City of Sanibel

COMMUNITY SERVICES DEPARTMENT Planning Staff Report

Planning Commission Agenda Item: № #7a.
Application Numbers: 21-12890V

RE: Consideration of an application filed pursuant to Land Development Code Section 82-138, Application and hearing, for a Variance to Land Development Code Chapter 126, Article XIV, Division 2, Subdivision II – Accessory Marine Structures, Section 126-875 Waterward Extension, to allow for a the construction of a new boat dock and boat lift to exceed the maximum permitted waterward extension limit (i.e., more than the maximum allowed 20 percent width of the waterway) as measured from the approximate mean high water line of the abutting human-made canal, accessory to a vacant residential parcel of land located at 5821 Pine Tree Drive (Lots 8B + 9B, Castaway Estates Unrecorded Subdivision – tax parcel No. 11-46-21-T3-00900.008B). The application is submitted by SteMic Marine Construction on behalf of property owners James A. + Deborah N. Fowler. Application No. 21-12890V.

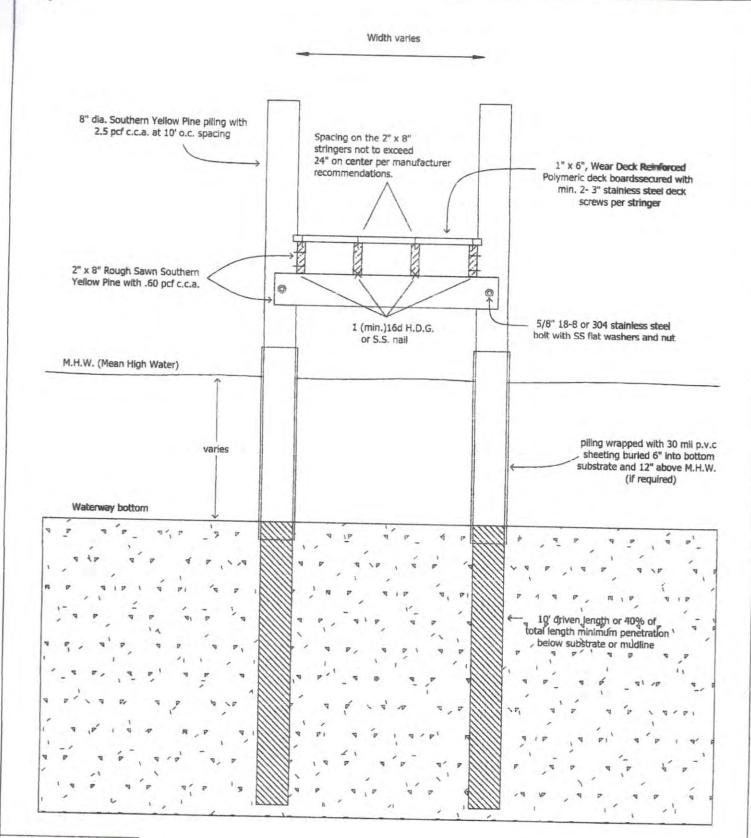
As shown on **Attachment E**, the proposed dock and lift will extend approximately 9 feet beyond the maximum permitted. To accommodate the proposed dock and boat lift, the applicant requests a variance to the maximum permitted waterward extension - to extend an additional 9 feet beyond the 20 percent limit, for a total waterward extension of 26 feet.

<u>Staff Comments:</u> The proposed 11-foot wide boat lift is of a standard size similar to others within the canal system. The proposed terminal platform is 4 feet wide, and 3 feet is the minimum dock width allowed by the Sanibel Code. Staff finds a reduction of proposed dock width from 4 feet to 3 feet would strictly satisfy this standard, unless other specific considerations for safety is recognized by Planning Commission.

- 2. Comply with the site plan provided as Attachment E, subject to revision of dock width from 4 feet (proposed) to 3 feet (minimum allowable), as to reduce the overall water-ward extension of marine accessory structures at the subject parcel.
